STATE OF MICHIGAN

DEPARTMENT OF NATURAL RESOURCES
LANSING

SUBJECT: Response to RAI – August 27, 2004, Tobico Marsh State Game Area Site
and Submission of Additional Information Relative to the Decommissioning Plan
Docket No. 40-9015, License No. SUC-1581

MDNR Response to Specifically Identified RAIs

Figure A Pathway Contributions to Building Surface Source Term TEDE

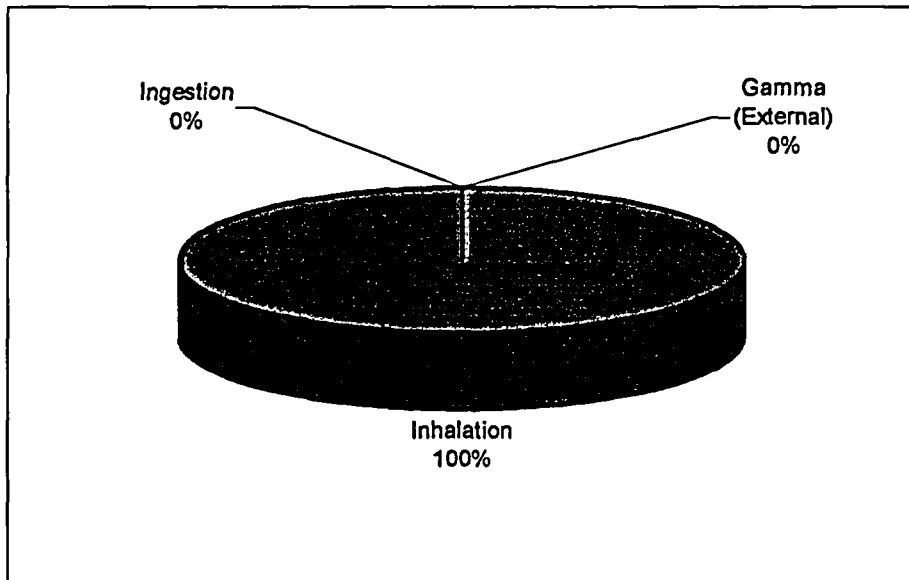
total effective annual dose. Figure A and Figure B illustrate the relative pathway and isotopic contributions to total effective dose equivalent resulting from the building surface DCGL.

Figure 9-2 Decommissioning Management Positions

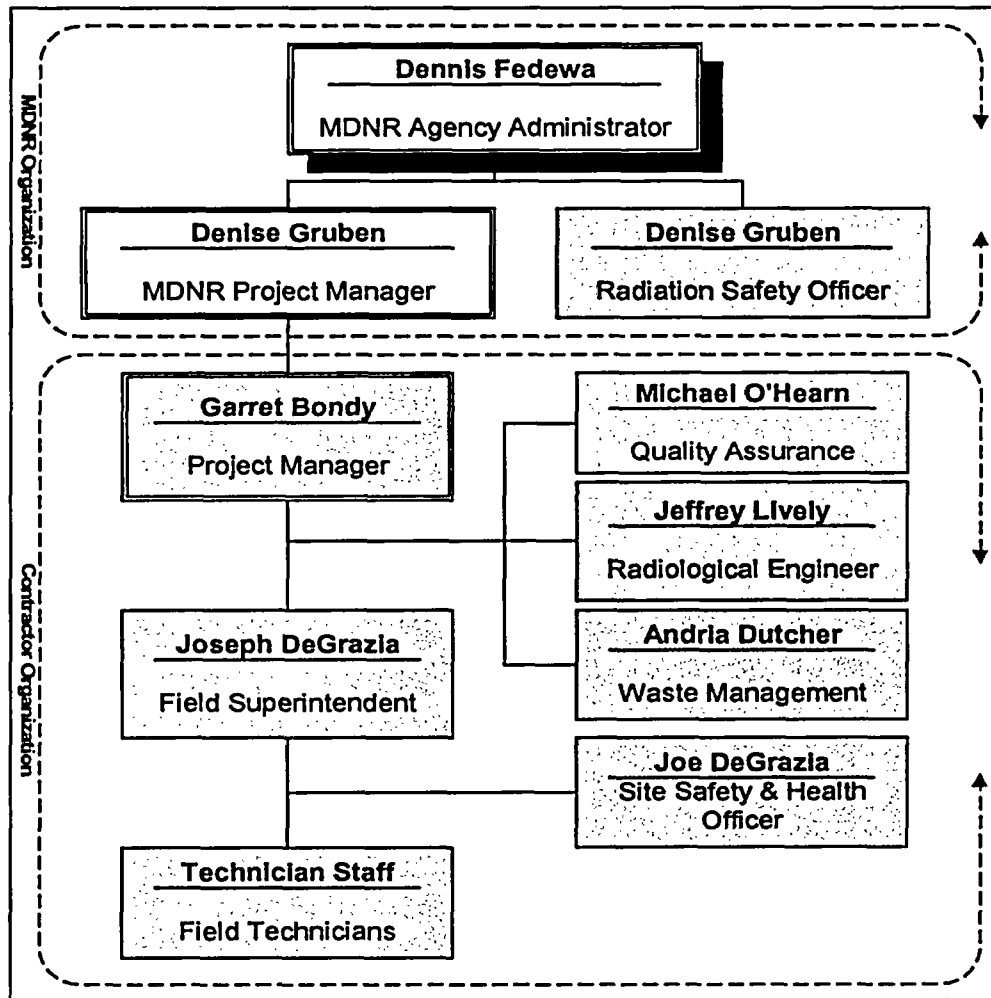
Figure 9-2, Page 9-5, (Organization Chart). A revised organization chart is provided to reflect personnel changes in key management positions.
